SUBJECT: UCAR Carbon Company Inc., Lawrenceburg, Tennessee
Evaluation of Elevated Activity in Soil in Accordance with NUREG/CR 5849

**Subject: Evaluation of Elevated Confirmatory Soil Sample – Building 5,
Room 108**

**Reference: Final Status Survey Report – Part 1 for Building 5 Annex and
Metallurgy Laboratory at the Formerly Licensed Union Carbide
Corporation Facility (UCC) Lawrenceburg, TN**

Building 5 Confirmatory Sampling

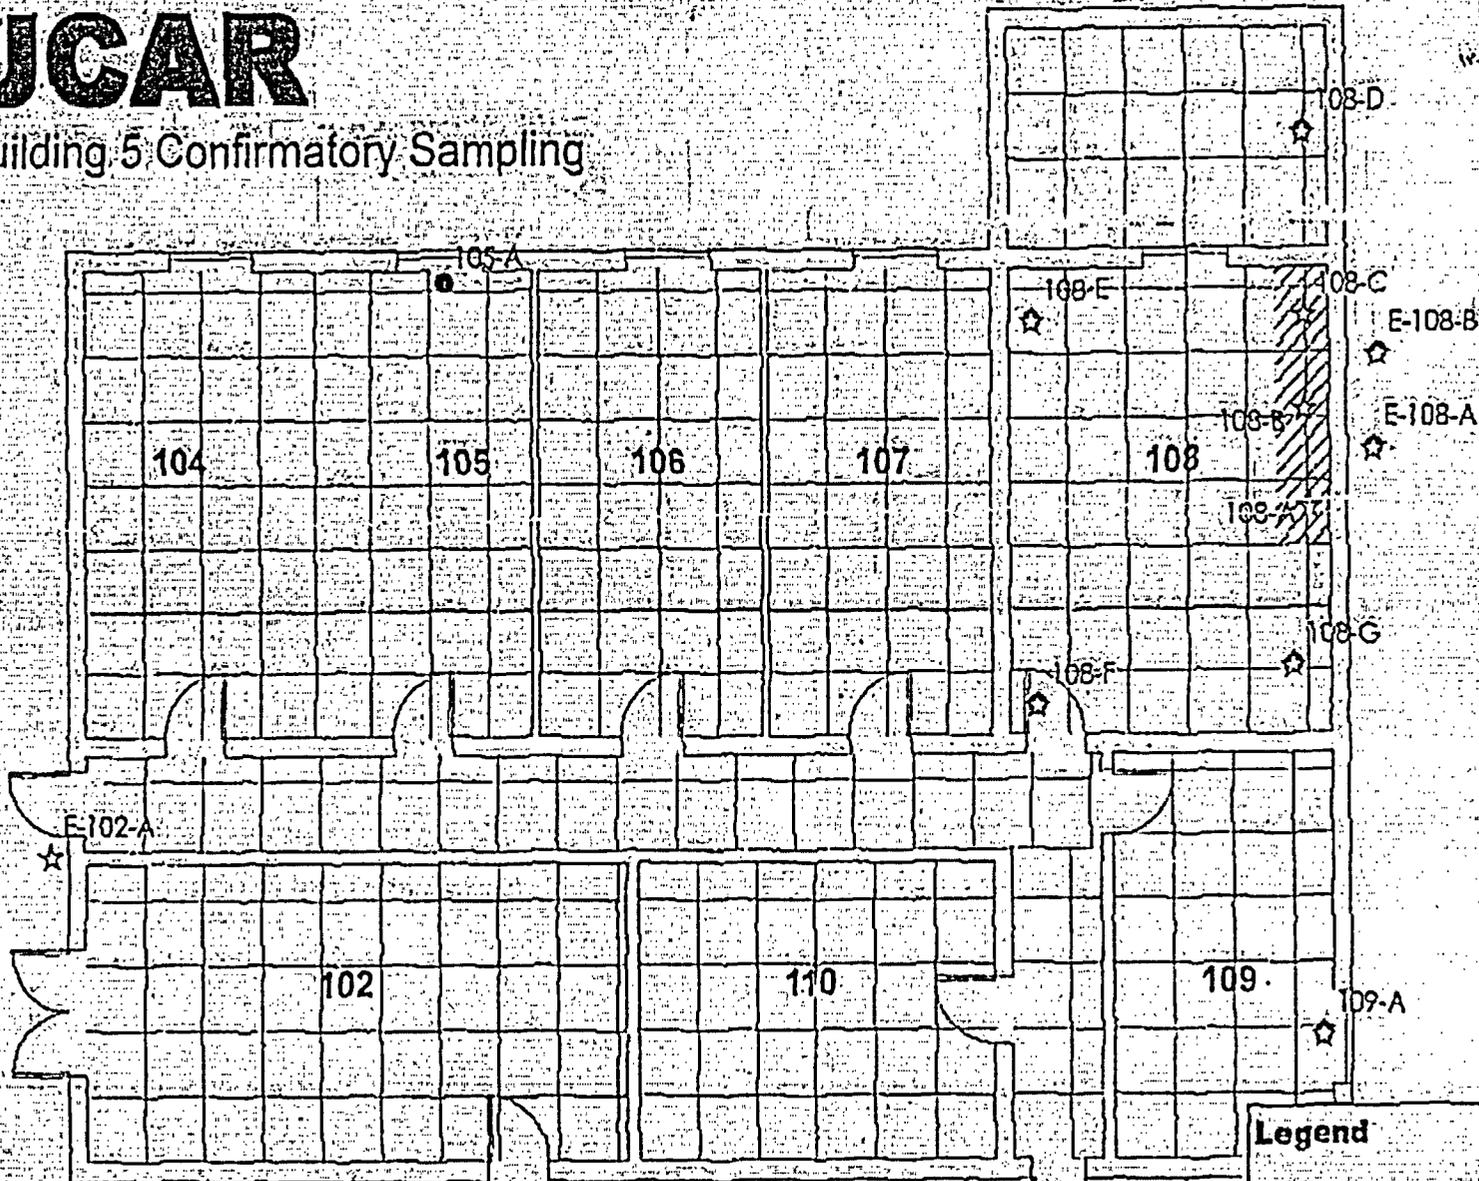
During remediation of Building 5, Room 108, NFS identified a seam between the east wall and the floor which exhibited elevated activity as measured by an alpha survey meter. As a result, a section of the concrete floor, approximately 1 meter x 4.5 meters, was removed and the small amount of soil adjacent to the east wall was removed. The wall was decontaminated and surveyed to demonstrate compliance with the release criteria. Six soil samples were collected from Room 108 and analyzed to confirm that the unrestricted release criteria had been met. Three samples were from the area where the concrete had been removed and three samples taken from the other corners of the room. The results of the NFS collected samples are presented in Table 1. A map of the building, showing sample and sampling grid locations, is attached.

Table 2 presents the results of the NRC confirmatory sample. As indicated, the NRC confirmatory samples not only significantly differed from the NFS collected samples but also exceeded the unrestricted release criteria for the U234 isotopic. The U235 and U238 activities of the NRC collected samples were less than the unrestricted release criteria (Table 3).

homogenized material and submitted for analysis. The NRC confirmatory samples did not follow this recommended approach. This sample was collected by compositing small aliquots of soil, removed from the top surface, from several locations within the uncovered area. The sample was then split into two aliquots and each aliquot analyzed. It is believed that this sample represent an isolated area of elevated activity and is not representative of residual uranium present in the entire room.

NUREG/CR 5849, Section 8.5.2 provides criteria for evaluating elevated areas of activity for compliance with the approved release criteria. Two criteria must be met. First, the soil activity at any location must be less than three times the release limit. The activity attributed to the U234 isotope, for both NRC sample results, is below three times the release limit. Second, the average concentration must be less than $(100/A)^{1/2}$ times the release limit, where A is the area of the elevated activity. For this test, the area of elevated activity is defined as the uncovered area (approximately 1 meter x 4.5 meters). The size of Room 108 is approximately 7.5 meters x 5.5 meters or 41.25 square meters. For conservatism, the size of the survey unit was limited to the size of the room. Therefore, the 41.25 m² instead of 100 m² was used in calculating the level of permitted activity. This calculation indicates that an elevated U234 concentration up to 990 pCi/g is permitted within this area and still met the unrestricted release criteria.

3. The uncovered area may be treated as an area of elevated activity using the NRC sample result (670 pCi/g) as the average U234 concentration within the area. Even so, the survey unit still passes the tests for compliance with the release criteria.

4. NFS chose to limit the survey unit to the size of the room (41.25 m²) rather than 100m² based on its contamination history and use only the samples collected inside this room in evaluation to determine if the release criteria had been achieved. Samples collected adjacent to Room 108 (108D, 109A and outside

samples E108A and E108B) are all at or slightly above background. This is further indication that contamination above the release criteria is not present at the survey unit level.

Notwithstanding the elevated result of the sample collected by the NRC, NFS believes no further remediation or sampling in this room is required for the following reasons.

In addition, NFS understands that the immediate plans are to pour new concrete over the uncovered area so that the area can be used to support plant operations. By covering the uncovered area with concrete, future worker exposure to any areas of elevated activity are eliminated. In addition, future remediation and/or construction activities impacting these soils will result in intermixing of any elevated soil with "clean" soil and debris thereby reducing and/or eliminating worker exposure.
